To: Mayor and Members of Woodstock Council

From: Eric Gilbert, Manager of Development Planning, Community Planning

Applications for Official Plan Amendment, Draft Plan of Subdivision and Zone Change OP 23-5-8, SB 23-03-8, ZN 8-23-07 (Farhi Holdings Corp.)

#2 View. Original Registered Plan with First and Secondary Access:

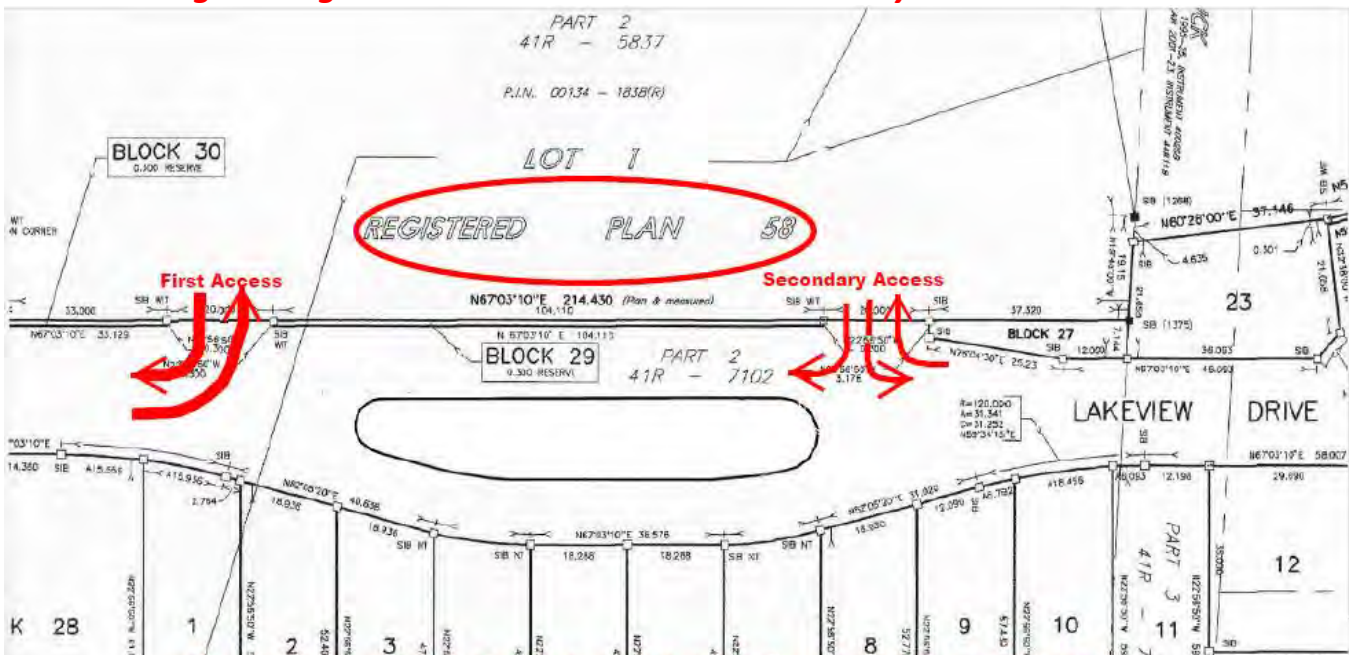
Two accesses per our registered plan and their safety per the existing traffic study. Most traffic will be in First Access.

#3 View Current Farhi's Application Showing one Access Oct.13,2024:

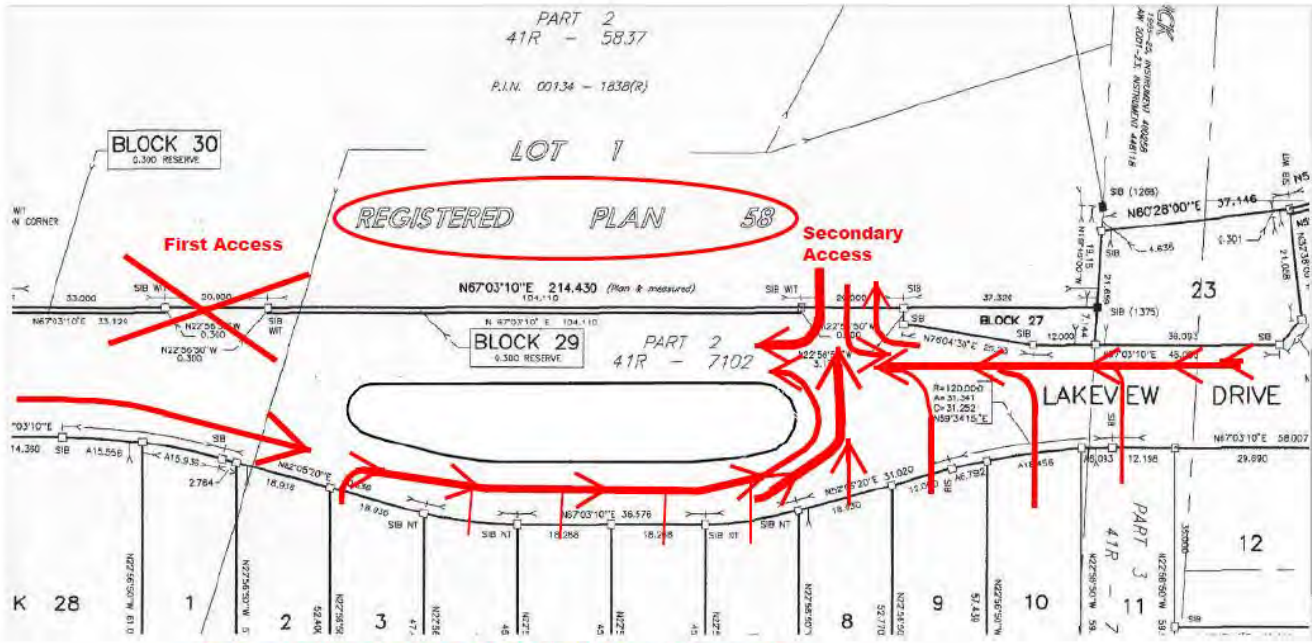
Farhi was advised by County Public Works to use the secondary east access to Lakeview Drive for any future development
